**Meridian Airport Authority, Dean Aircraft Services
Hangar Additions & Alterations**

ADDENDUM NO. 2

TO: All Bidders on the Above Referenced Product
FROM: Davis Purdy Architects, PLLC
DATE: March 12, 2020
SUBJECT: **ADDENDUM NO. 2**

4 RECEPTION DESK REAR
1/2" = 1'-0"

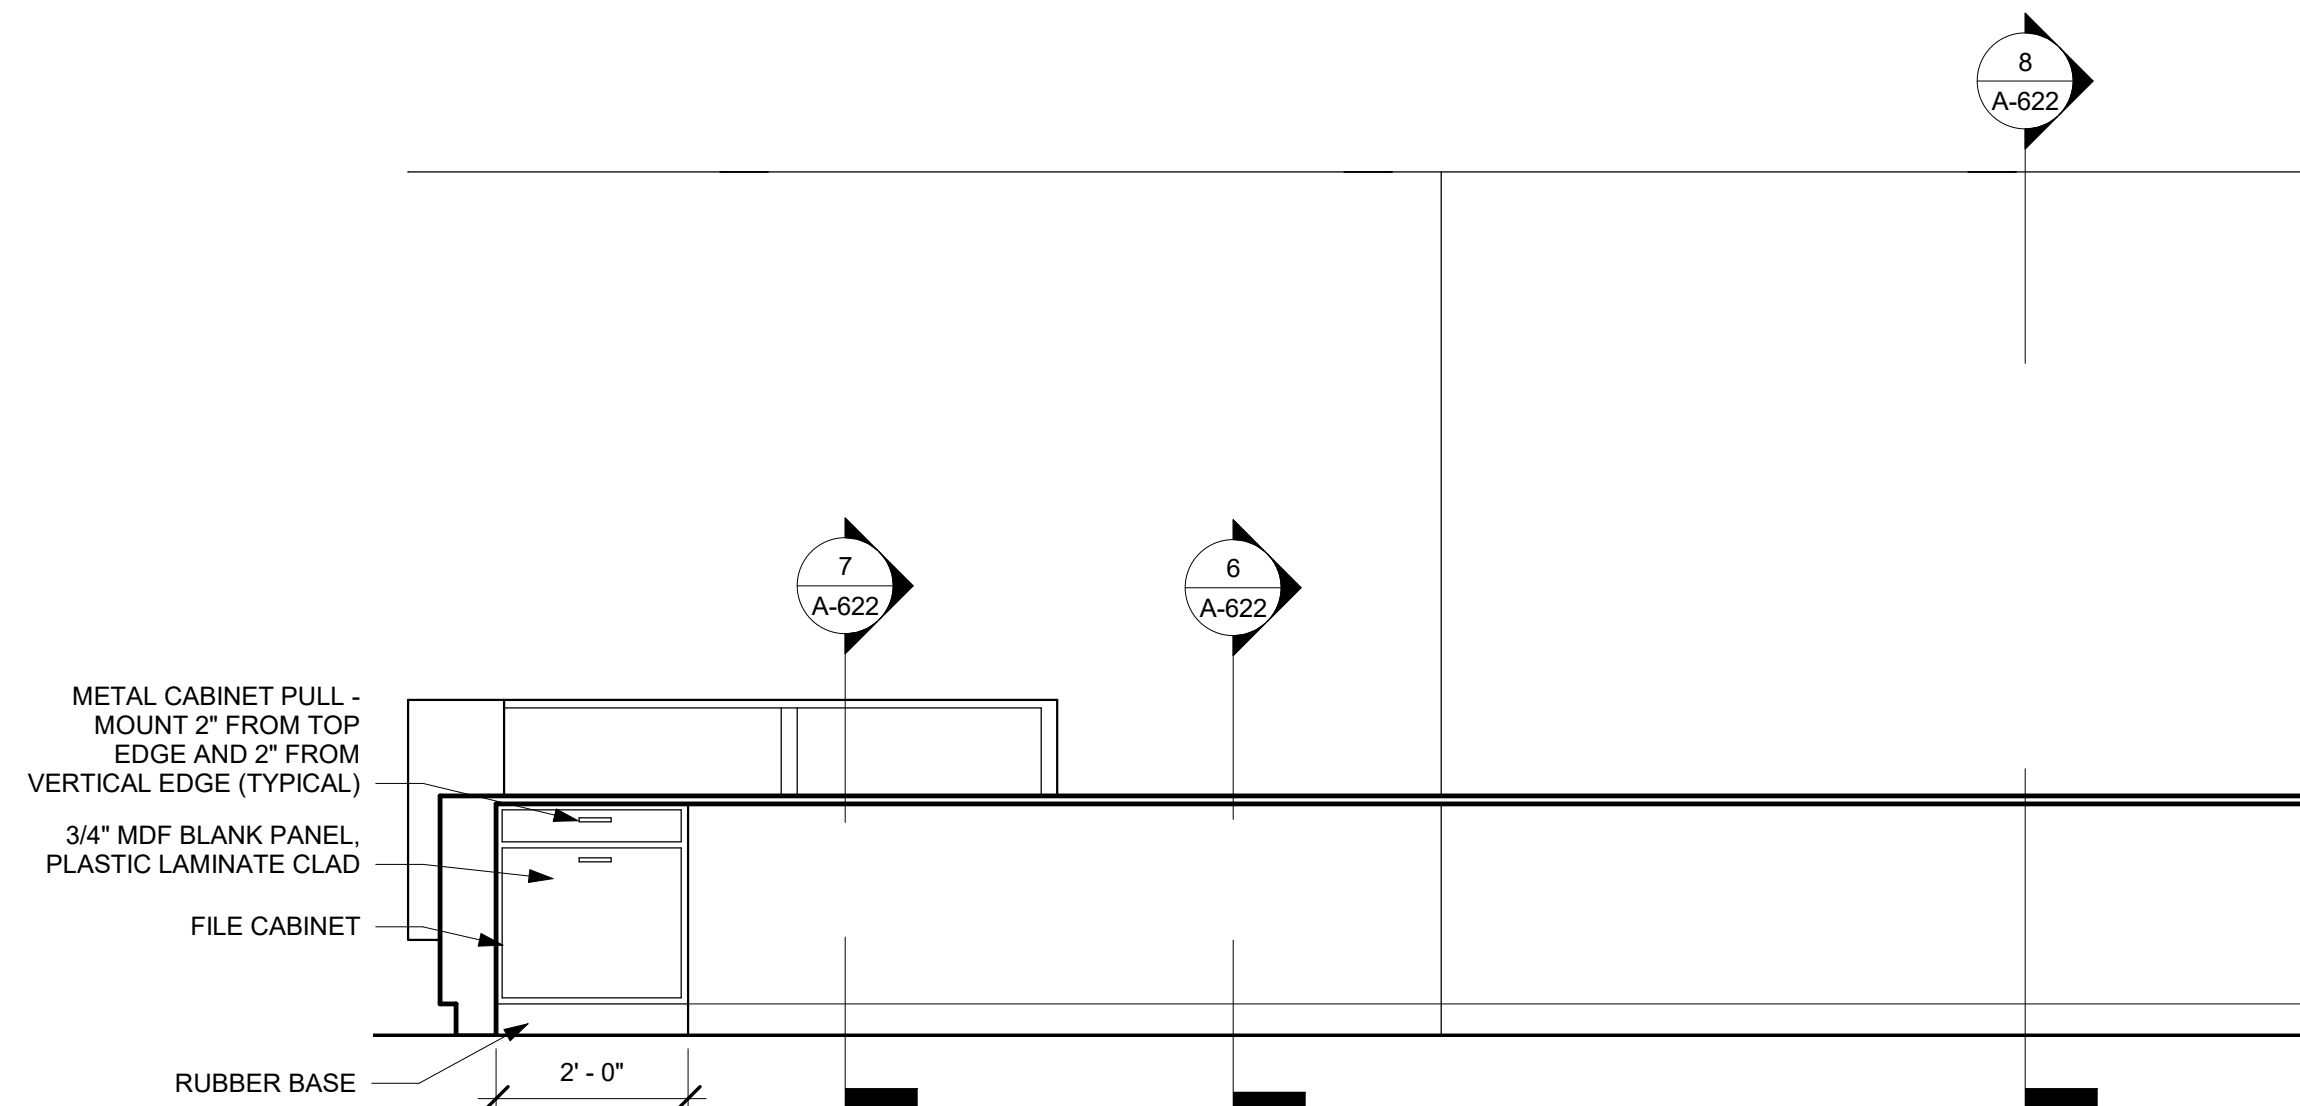
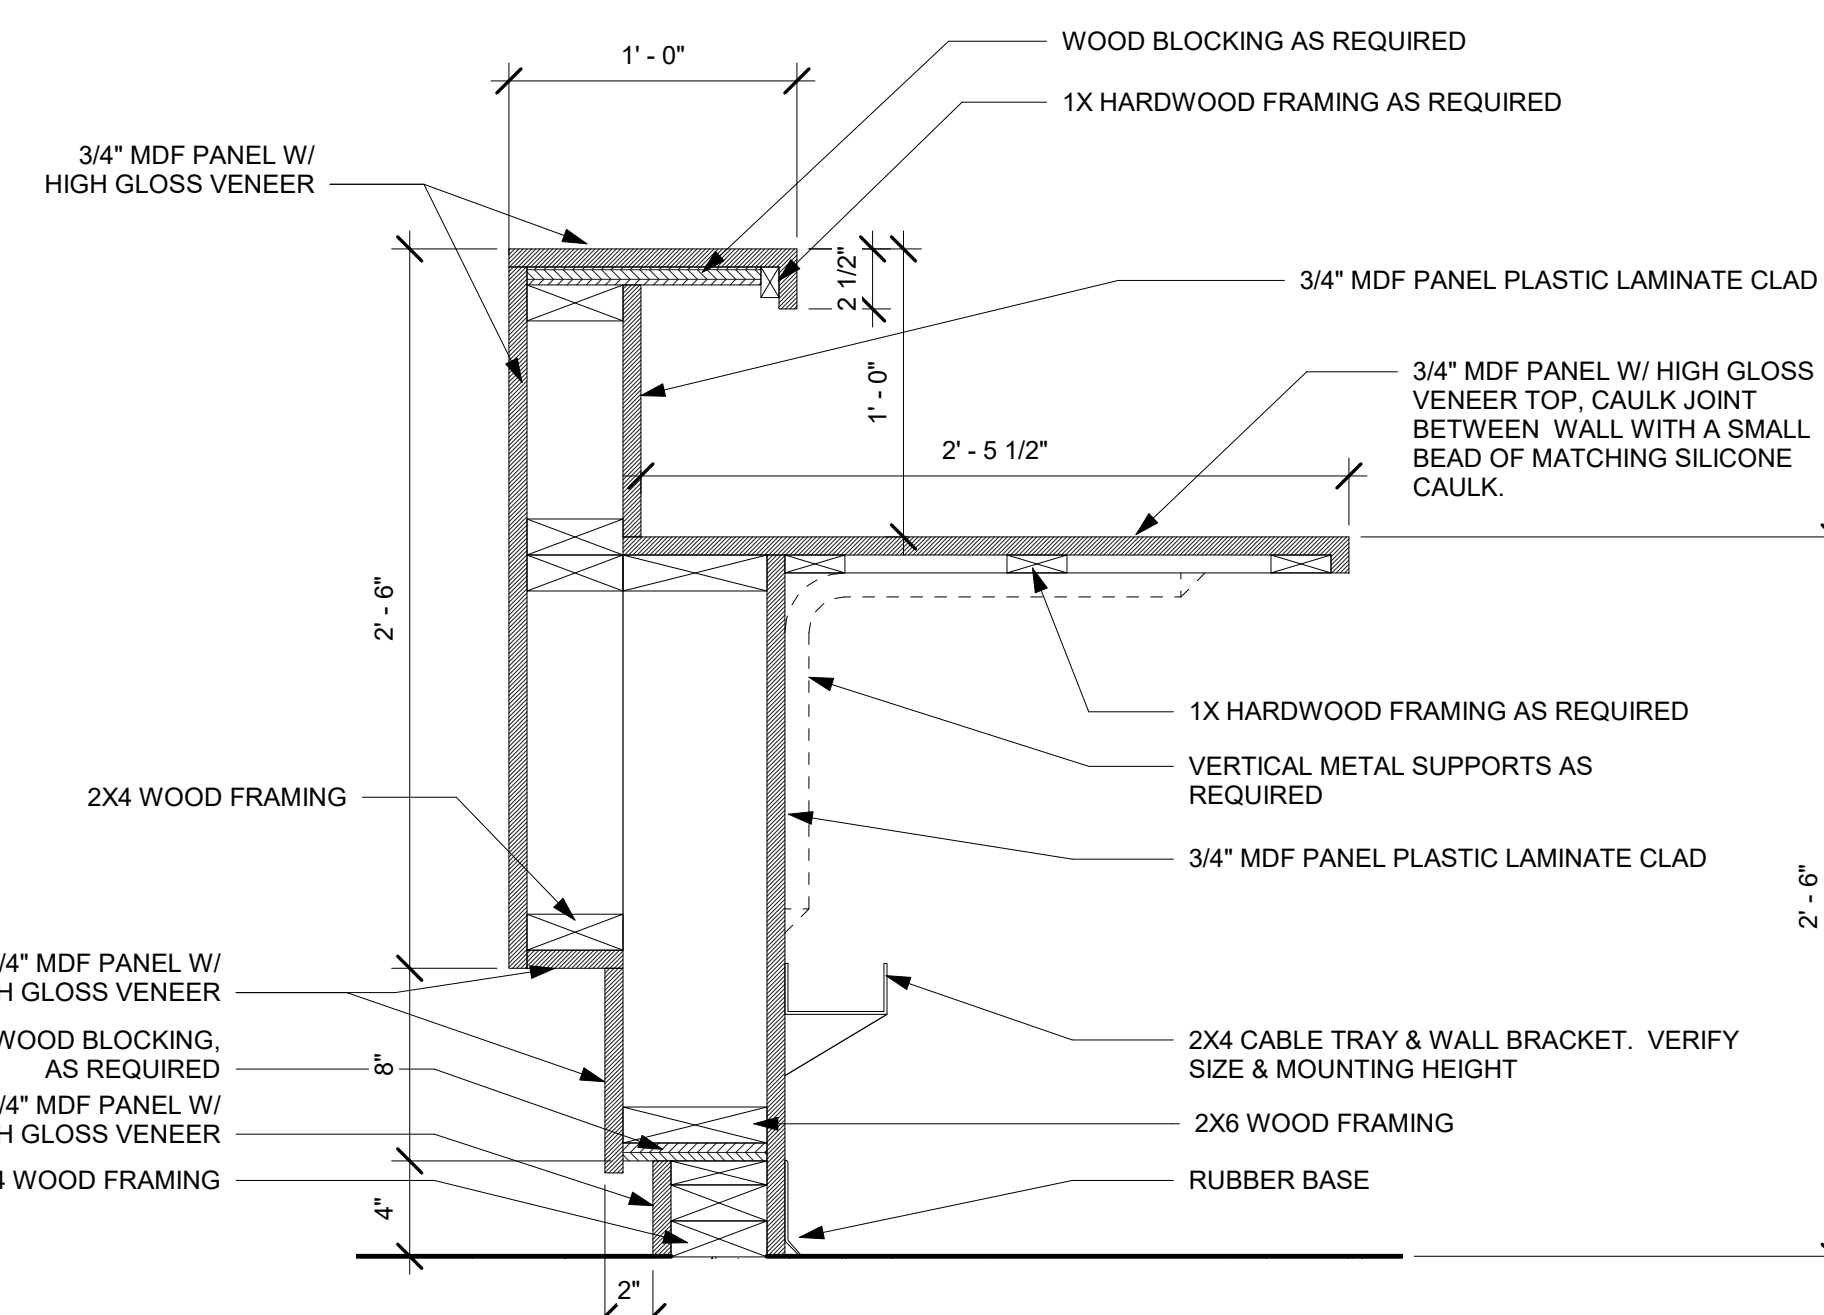
47. REPLACE: Replace the Architectural sheet A-622 MILLWORK dated 2/28/20 with Architectural sheet **A-622** dated 3/12/20. Sheet A-622 is attached.
